Subject: Fuel Leak Case No. [REDACTED] Shell#13-5243, 11989 Dublin Blvd., Dublin, CA

Alameda County Environmental Health (ACEH) staff has reviewed the case file for the above referenced site and the document entitled, "Off-Site Well Installation Report," dated August 24, 2006, prepared on behalf of Shell by Delta Environmental Consultants, Inc. The Off-Site Well Installation Report presents the results from installation of two monitoring wells (MW-6 and MW-7) on property east of the site and San Ramon Road. The report indicates that well MW-6 is beyond the downgradient edge of the dissolved-phase hydrocarbon plume and provides a sampling point with which to monitor to be used to monitor the downgradient portion of the plume. Well MW-7 is screened within a deeper groundwater zone and is to be used to monitor the vertical stability of the plume. The report concludes that plume delineation is complete and recommends that wells MW-6 and MW-7 be added to the quarterly monitoring program. We concur that wells MW-6 and MW-7 are to be added to the quarterly groundwater monitoring program in order to confirm plume stability.

Alameda County Environmental Health (ACEH) staff has reviewed th

Figure
2
Project No.
3095.06

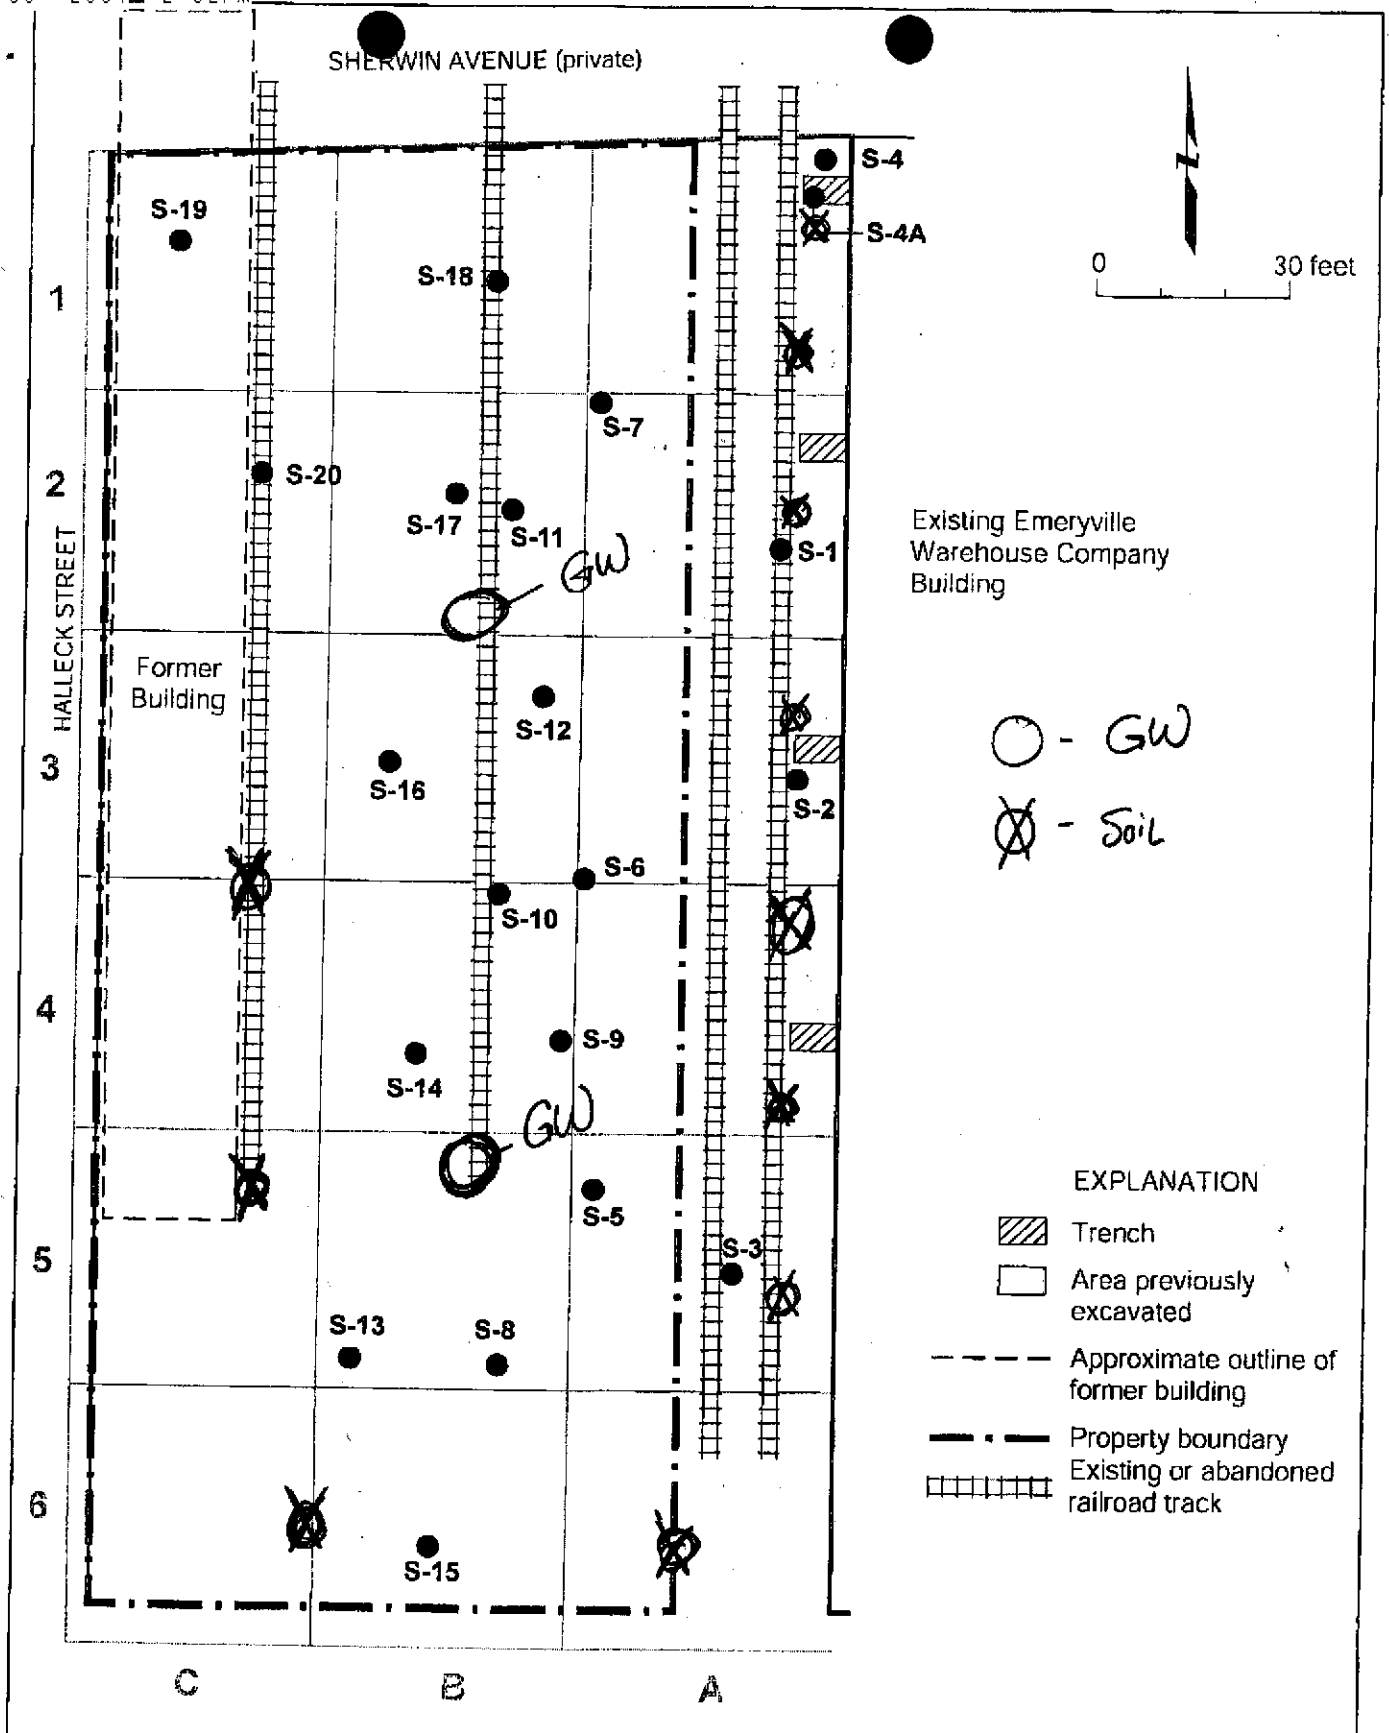
Given the previous detection of a low concentration of TPH-g in groundwater at the northwestern corner of the site, two groundwater samples will be collected to assess the potential for concentrations of BTEX, the toxic constituents of gasoline. Since the future likely use of shallow groundwater in Emeryville is highly unlikely, and the concentrations of metals found in site groundwater to-date are relatively low, additional analysis of groundwater for metals is not recommended for the summary report. This response is not sufficient. We recommend that you evaluate the distribution of the detected contaminants.

A figure showing recommended sampling locations is included with this Memorandum by fax. As we have discussed, we would appreciate your input on our approach prior to proceeding with the sampling program. If you have any questions, please call me at (415) 290-5034, or Jennifer Patterson at (510) 663-4167.
